BCA & DDA COMPLIANCE ASSESSMENT REPORT PROPOSED ALTERATIONS & ADDITIONS TO EXISTING CHILDCARE CENTRE BAMBARA ROAD, BELROSE

MSA0542AA- REV 00

WARRINGAH COUNCIL

02.08.2013

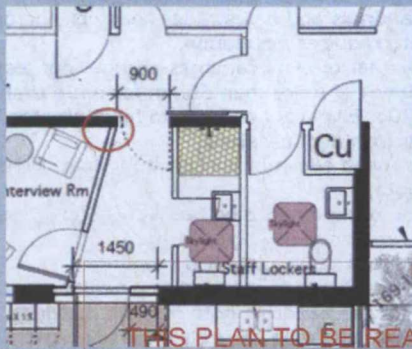
Clause 10.4 Curved walkways, ramps, and landings Curved walkways, ramps and landings shall: - landings to comply with Clause 10.8, - length measured horizontally on centre-line, - min. width of 1.5m, - crossfalls towards centre of curvature.			X	NA
Clause 10.5 Threshold ramps Threshold ramps at doorways to have a max. rise of 35mm, max length of 280mm, max gradient of 1:8 and be located within 20mm of the door leaf.		X		The rise of the current threshold ramp is ≈35mm, which is permissible, however the run is ≈145mm, which creates a gradient steeper than 1:8 (≈1/4) THIS PLAN TO BE READ IN CONJUNCTION WITH The threshold ramp must be modified so as to comply with this clause <i>Details to be included on</i>

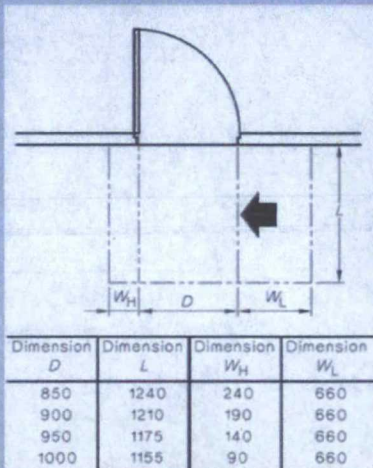
Clause 13.3 Circulation spaces at doorways on a continuous accessible path of travel <u>General</u> Circulation spaces shall be provided at every doorway, gate etc on accessible path. Circulation spaces to have max. gradient or crossfall of 1:40. Circulation to be applied to both sides of the door. Dimensions apply in mirror image configurations and intermediate sized openings shall have circulation spaces interpolated. <u>Swinging doors</u> Clear circulation space at doorways is based on clear opening width of the door, and angle of approach. See Figure <u>Sliding doors</u> Clear circulation space at doorways is based on clear opening width of the door. When a sliding door is within the wall cavity, the circulation shall be not less than Table of Figure 32. Where surface-mounted, the circulation space at the door face shall be min. as per the Table of Figure 32, whilst the opposite face to be increased by the values of the Table of Figure 33.		X		The doors are generally provide with compliant circulation space, with the following exceptions noted: • The latchside circulation space to the proposed sliding door will not satisfy Figure 32 (d) of AS1428.1-2009 (see plan extract below) This non-compliance could be alleviated by providing a power operated door – Details to be included on the construction certificate documentation

TECHNICAL PROVISION	COMPLIES	DOES NOT COMPLY	NA OR INFORMATIONAL COMPLIANCE REQUIRED	COMMENTS																				
				 The circulation space to the outside of the doorway must be provided in accordance with Figure 32 (b) of AS1428.1-2009 – details to be provided with the construction certificate documentation
